What to do with TP0a and TP5a

802.3ck Chief Editor

Thoughts on TP0v

Figure 163-3—Transmitter test fixture and test points

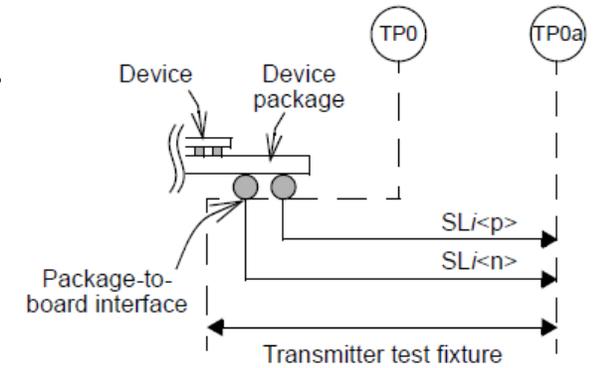
D1.2 comment #33/#153 request TP0a is to be replaced by TP0v.
The main differences are (a) the insertion loss may vary but must be less than specified max value and (b) methodologies were provided to account for the actual characteristics of the test fixture.
TP0a is to be retained as an informative specification (or example).

TP0a has been shown to be extremely difficult to be used as a point to measure Specified Tx compliance parameters.

(Cross-clause)
The test feature normative insertion loss requirements are not realistic for real devices, especially with multiple lanes.

Also, as presented in http://www.ieee802.org/3/ck/public/20_01/mellitz_3ck_01a_0120.pdf, the variations allowed within the recommendations create significant variations in results of compliance parameters. This is obviously not a viable methodology anymore.

It is suggested to replace the test fixture requirements with an explicit equation describing s-parameters of a transmission line with 4 dB IL (using equation 93A-14 with appropriate parameters) such that TP0a is well-defined, and create informative specifications at this TP0a. Alternatively, informative specifications can be given at TP0.

The new test point TP0v and related test fixture are adopted per the response to comment #33.

Retain the TP0a test point and test fixture specifications, but change to an informative specification.

Figure 163-4—Test fixture reference insertion loss

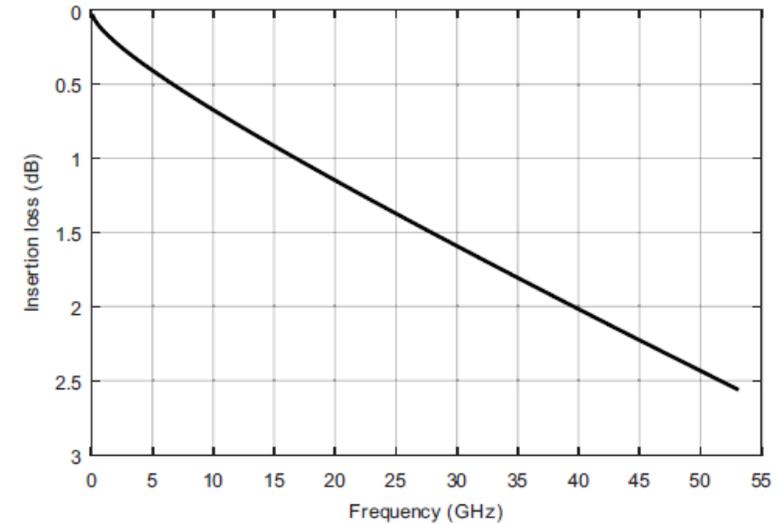
Per D1.2 comment #153 the test fixture with TP0a specifications was retained as an example for a TPO to TP0v test fixture.

- Once we determine the characteristics of the reference transmitter...
 - we are shifting the reference specifications from TP0a to TP0
 - for measurements we are translating them to TP0v
 - TP0a becomes moots and there is no value in retaining it
- Recommendation
 - Delete the example test fixture and any references to term TP0a
 - Define specifications based on requirements at TP0 and translate them to TP0v.

Figure 163A-1—Measurement method for transmitter reference steady-state voltage, pulse peak and ERL

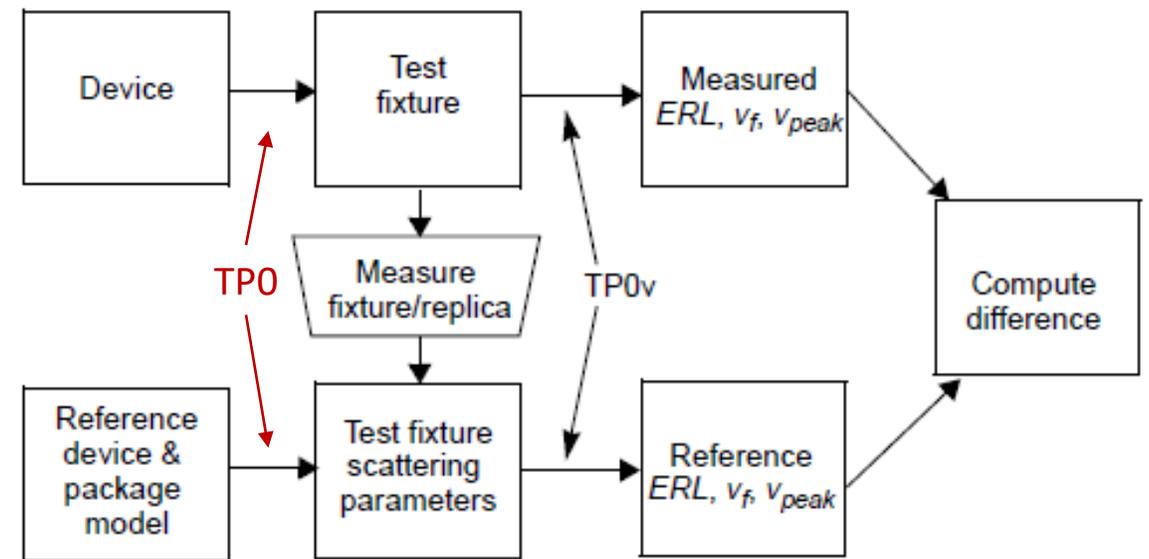
The variation in insertion loss of the TP0 to TP0v TF is accounted for by determining the expected output given a marginal reference transmitter according to the method specified in new Annex 163A.

For this scheme to be consistent with the previous TP0 to TP0a TF, the reference transmitter must be specified such that the calculated results at TP0v (bottom path) are the same as those we previously specified using the TP0 to TP0a. Once this translation is done, the previous TP0a specifications are moot.

Figure 163–5—Receiver test fixture and test points

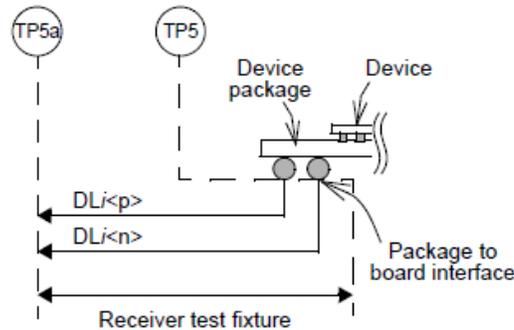
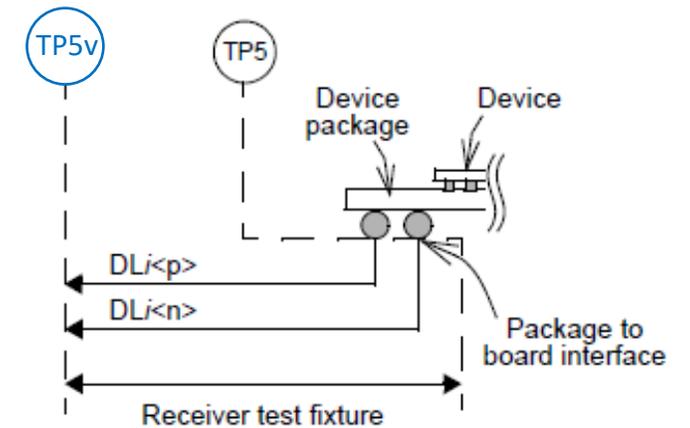
In D1.3, the Rx TF was not updated to align with the updated Tx TF.

Change the Rx test fixture specification to align with the Tx test fixture specification as follows:

Unless otherwise noted, measurements of the receiver are made at the input of a test fixture (TP5v) as shown in Figure 163–5 and as described in Annex 163A.

Replace references to TP5a with TP5v.

Replace receiver ERL specification with dERL specification used for Tx.
